GIRDWOOD TRAILS PLAN

Public Review Draft – Recommendations for Changes/Edits

RE: GTP Public Review Draft

Recommended Changes

NS1: Virgin Creek Natural Space

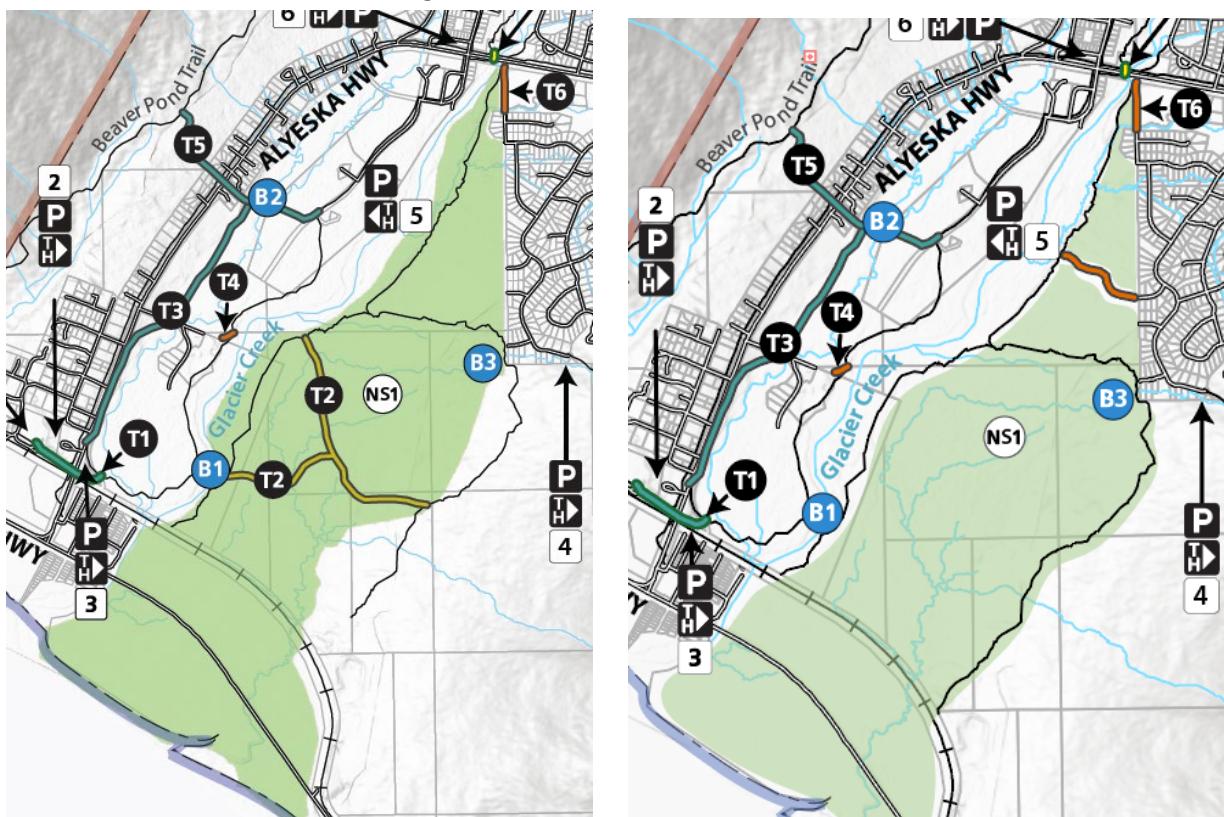
Recommend adjusting the boundary of NS1. The eastern boundary should extend and include the Wagon Trail. The western boundary should be adjusted to remove the Joe Danich Trail from NS1. ADD a trail project to the plan that brings the Joe Danich up to a Class 3 trail constructed to the bicycle design parameter and relocate out of wetlands to uplands. ADD trail project to the plan to construct neighborhood connector trail (Class 3, bicycle design parameters, constructed in uplands) from the Turin and/or Carlina Drive cul-de-sacs to connect to the Joe Danich trail. NS1, with the adjusted boundary, remains non-mechanized with trails that are no greater than Class 2. Comments indicate that residents want a multi-use

alternative trail to connect from the lower valley to the upper valley without using the road system. A Class 3 designation provides a sustainable connection to neighborhoods. The eastern boundary shift better aligns with a primitive experience for the Wagon Trail.

NS2: Stumpy's Natural Space

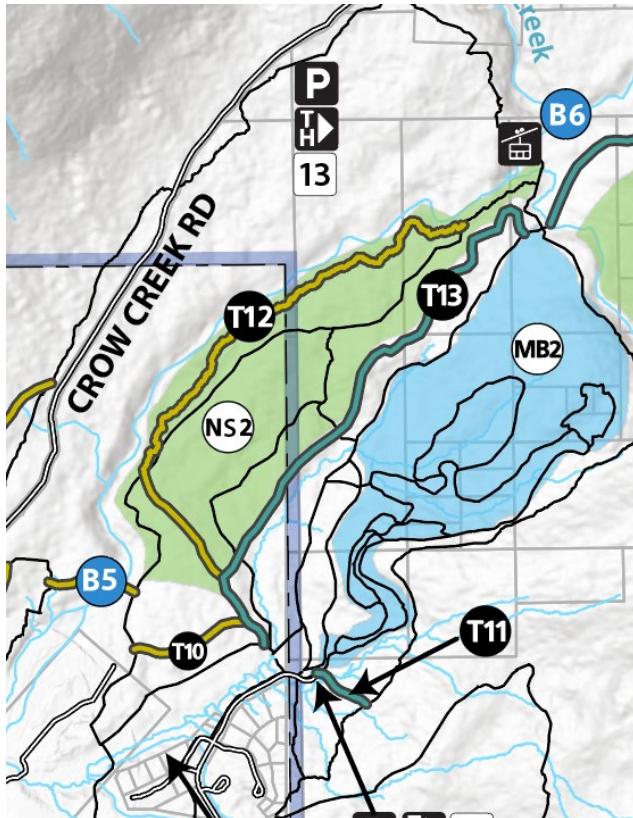
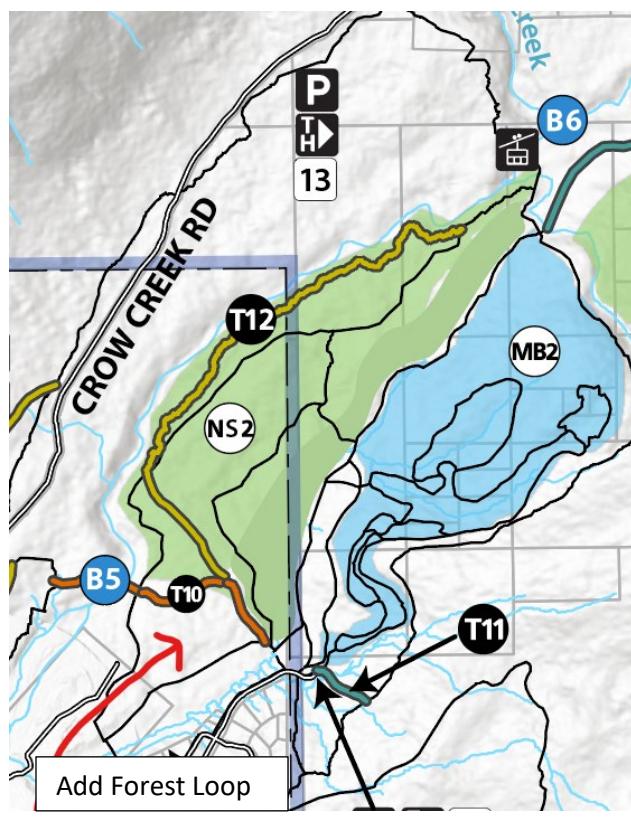
Recommend adjusting the boundary of NS2. Expand the boundary to the east to extend up to but not including the Snowcat Trail and the groomed section of Stumpy's winter trail. (T13-Upper Valley Multi-Use Trail recommended to be removed from the draft plan and add Forest Loop back).

MB1: Beaver Pond MB Area

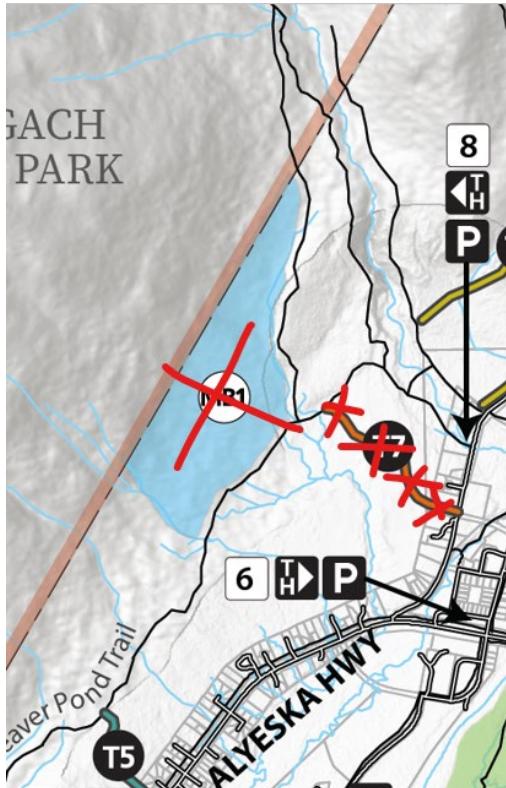
CHANGE RECOMMENDED – Remove MB1 from the plan:

There is not consensus about this project. Needs more discussion – if included in the plan MB1 shall be developed in consultation with the Girdwood Trails Committee only after MB2 is complete. If MB1 is removed, user conflicts on Abe's and California Creek Trails still need to be addressed.

KEEP MB1 in the PLAN

TH 3

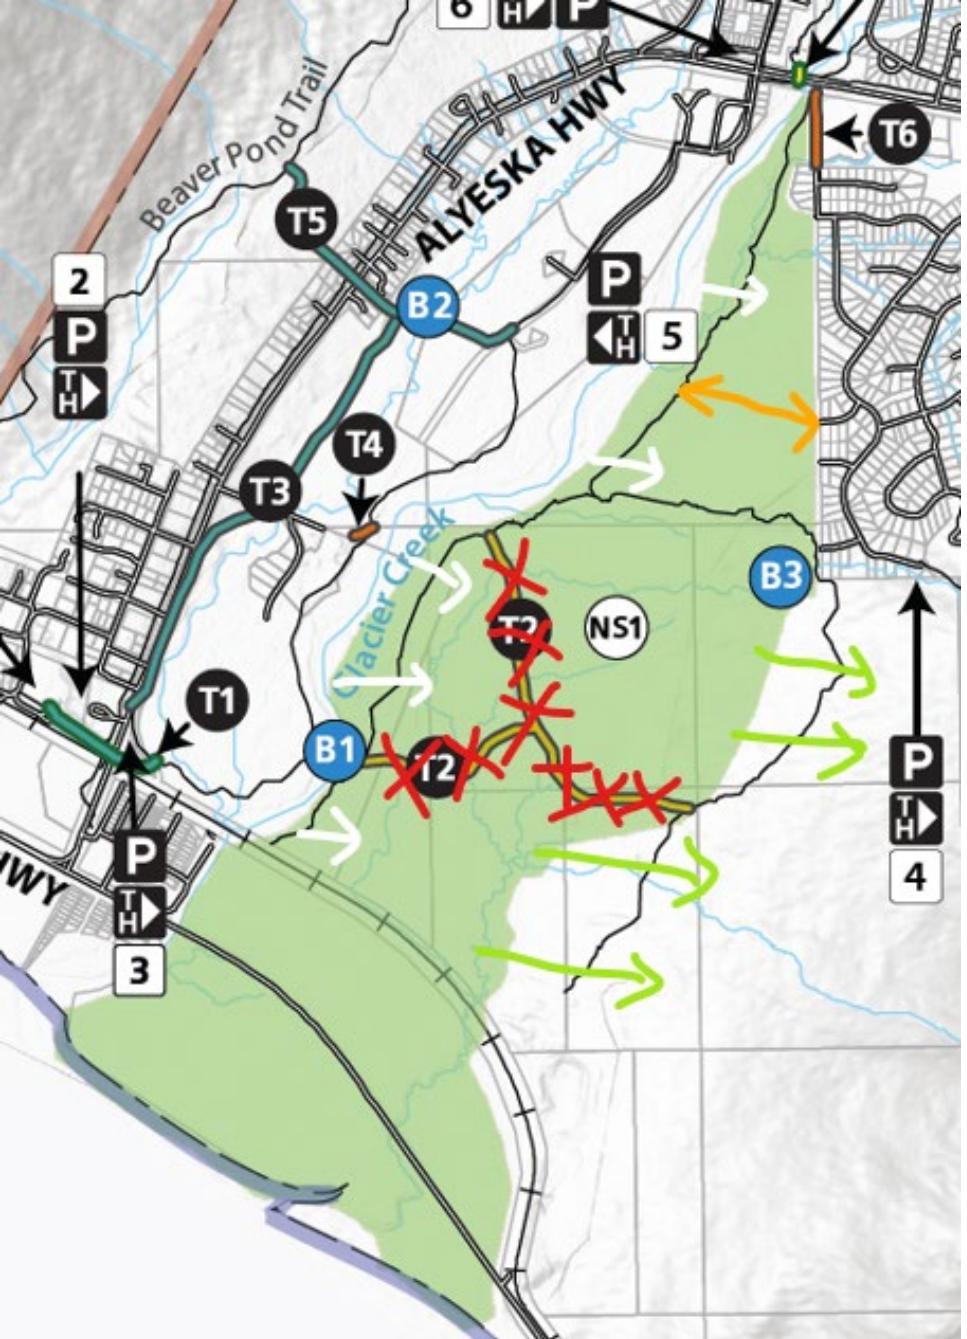
CHANGE RECOMMENDED – Remove this trailhead from the plan.

WHY: Comments indicated there was not public support for this trailhead.

NS1: Virgin Creek Natural Space

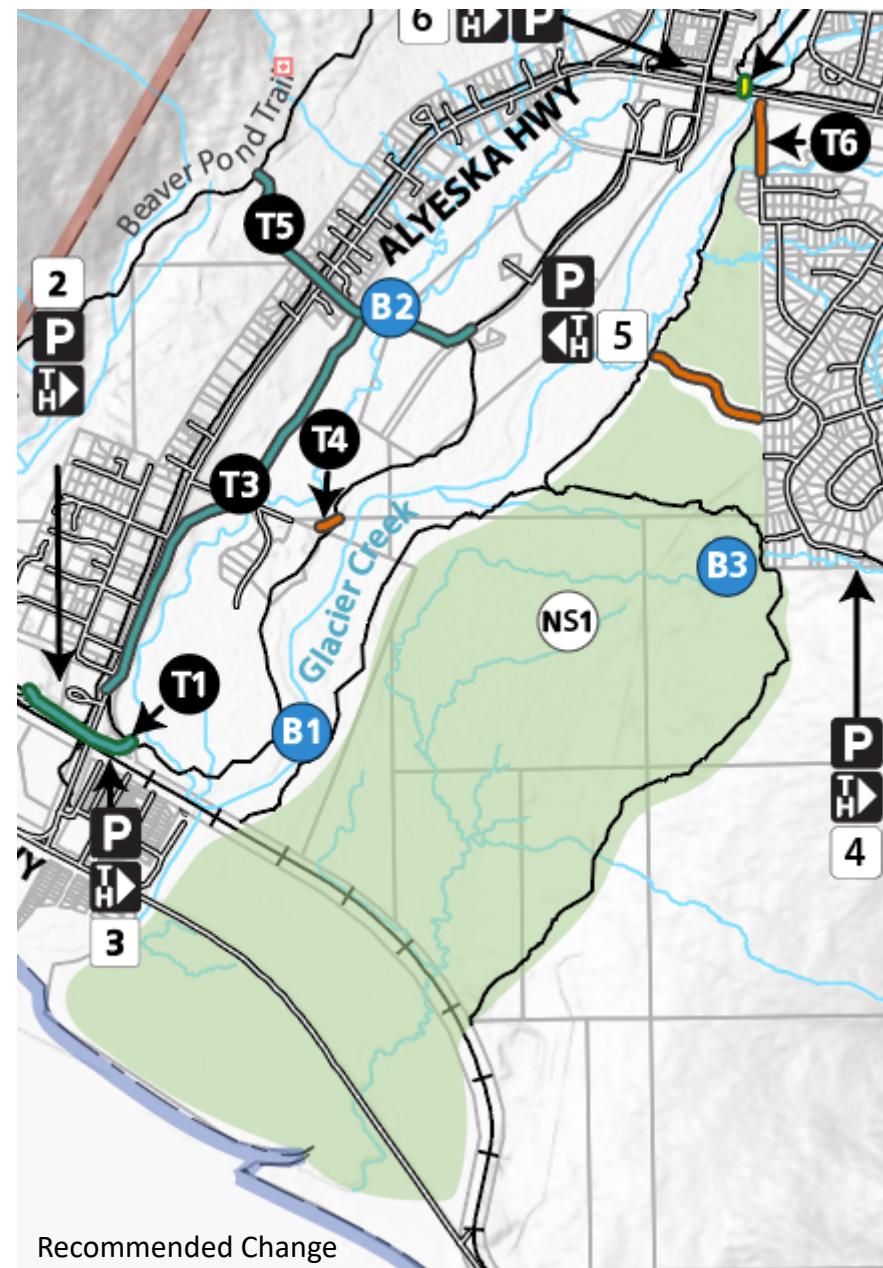
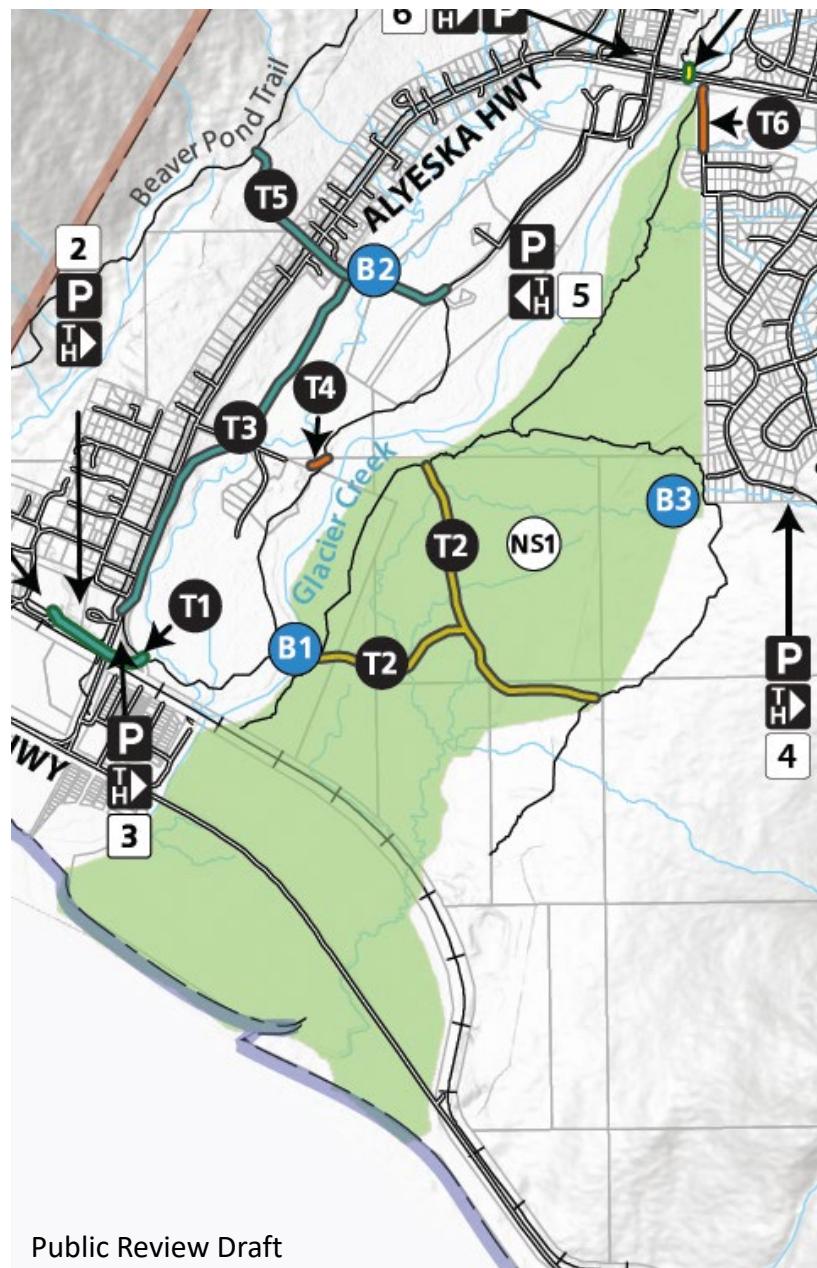
Recommend adjusting the boundary of NS1. The eastern boundary should extend and include the Wagon Trail. The western boundary should be adjusted to remove the Joe Danich Trail from NS1. ADD a trail project to the plan that brings the Joe Danich up to a Class 3 trail constructed to the bicycle design parameter and relocate out of wetlands to uplands. ADD trail project to the plan to construct neighborhood connector trail (Class 3, bicycle design parameters, constructed in uplands) from the Turin and/or Carlina Drive cul-de-sacs to connect to the Joe Danich trail. NS1, with the adjusted boundary, remains non-mechanized with trails that are no greater than Class 2. **WHY:** Comments indicate that residents want a multi-use alternative trail to connect from the lower valley to the upper valley without using the road system. A Class 3 designation provides a sustainable connection to neighborhoods. The eastern boundary shift better aligns with a primitive experience for the Wagon Trail.

MB1: Beaver Pond MB Area

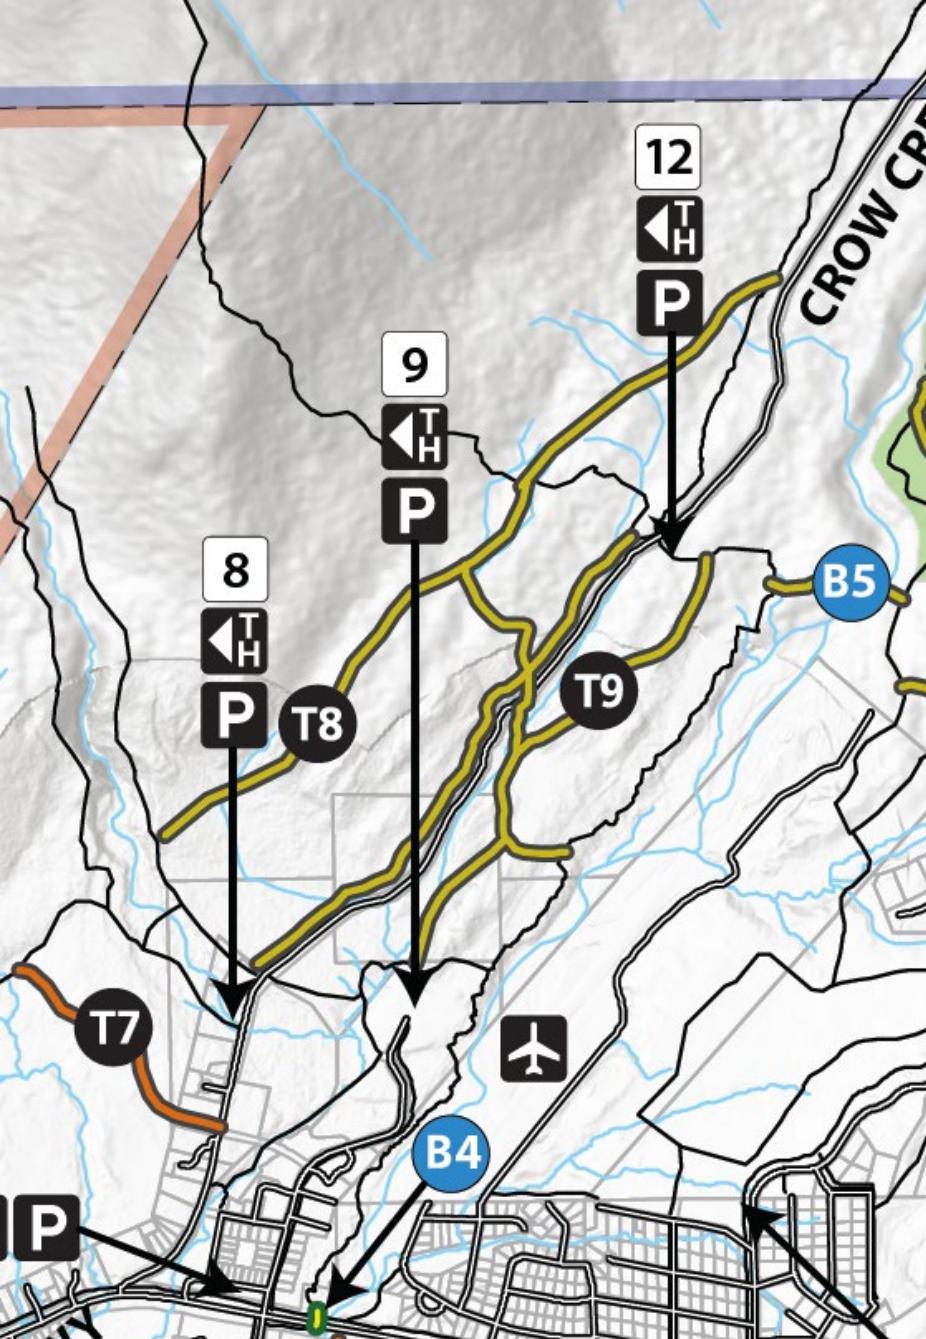
CHANGE RECOMMENDED

Recommend removing MB1 from the plan. **WHY:** There is not consensus about this project. Needs more discussion – if included in the plan MB1 shall be developed in consultation with the Girdwood Trails Committee only after MB2 is complete. If MB1 is removed, user conflicts on Abe's and California Creek Trails still needs to be addressed.

NS2: Stumpy's Natural Space

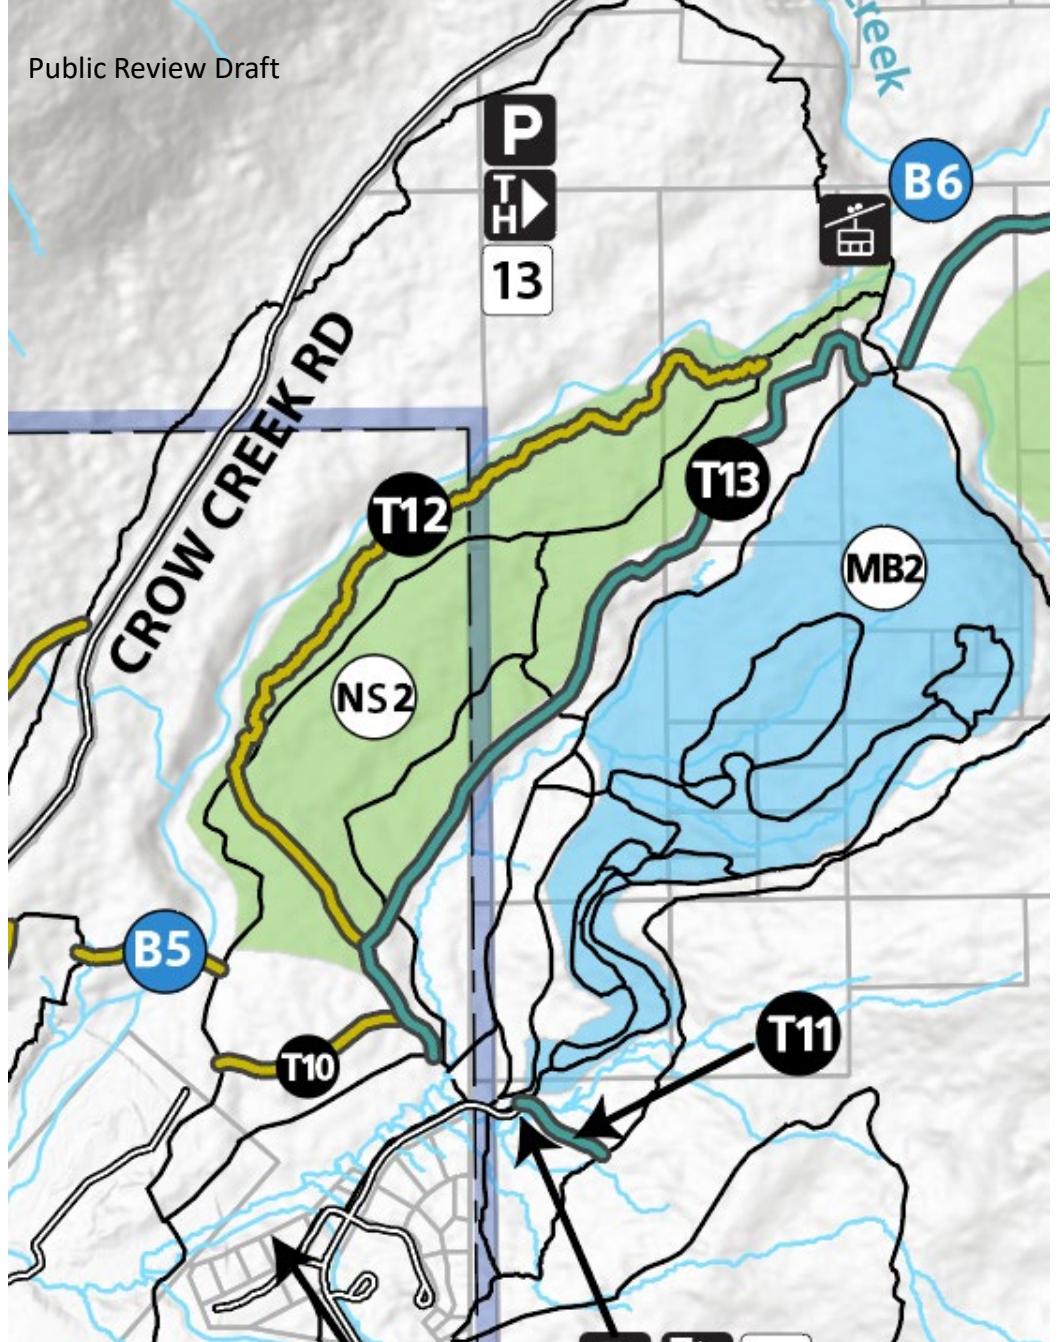
Recommend adjusting the boundary of NS2. Expand the boundary to the east to extend up to but not including the Snowcat Trail and the groomed section of Stumpy's winter trail. **WHY:** There isn't consensus for T13 and the wetlands are better suited for a more primitive experience.

Upper Valley Recommended Changes

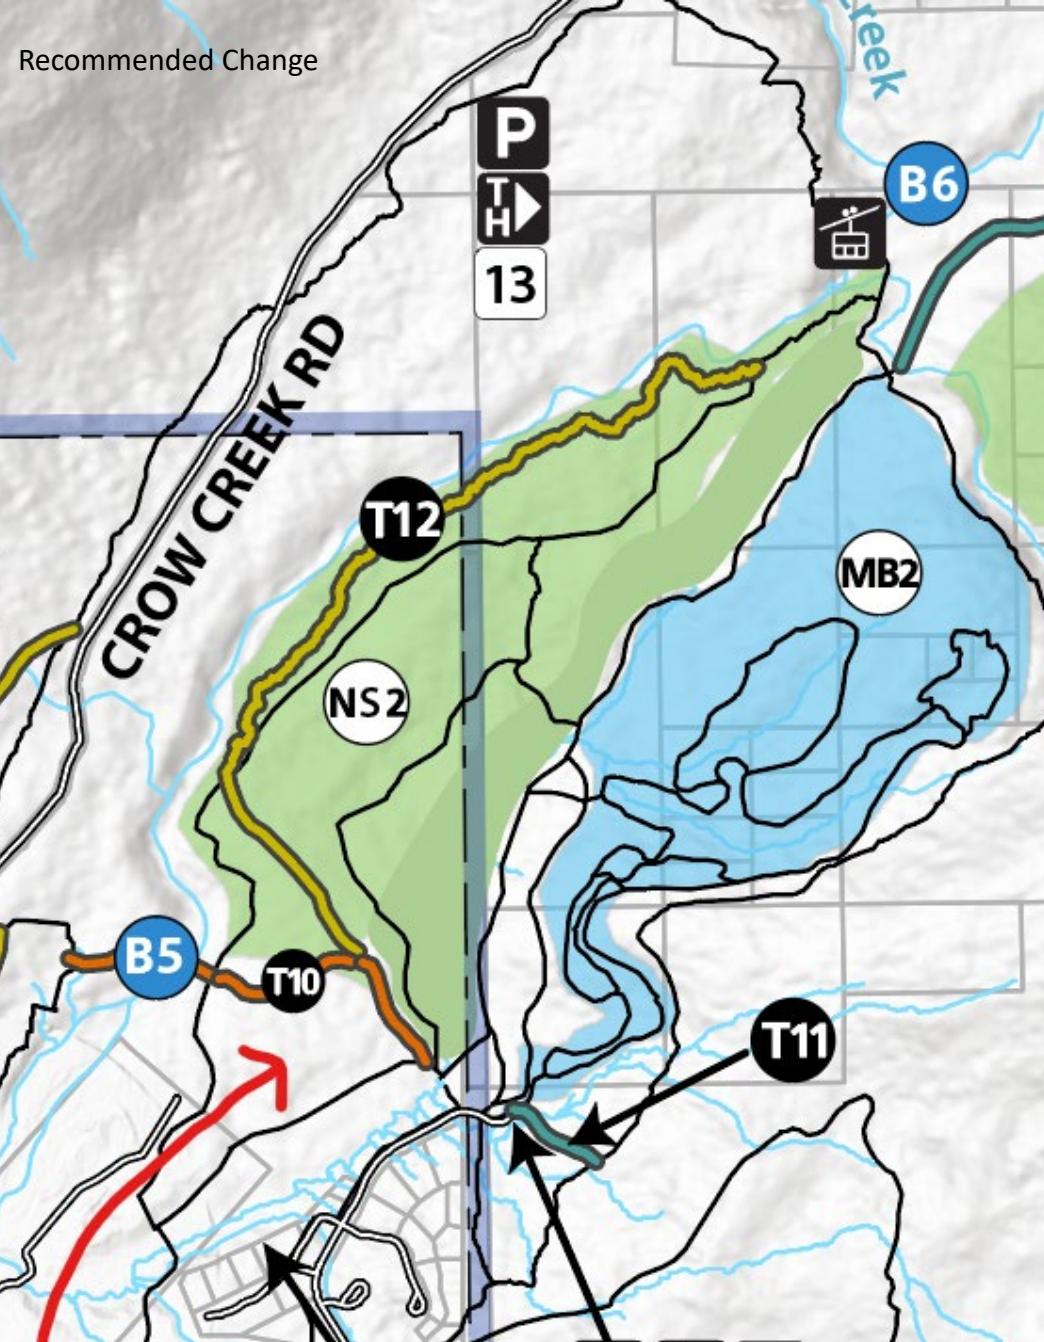
ADD FOREST LOOP
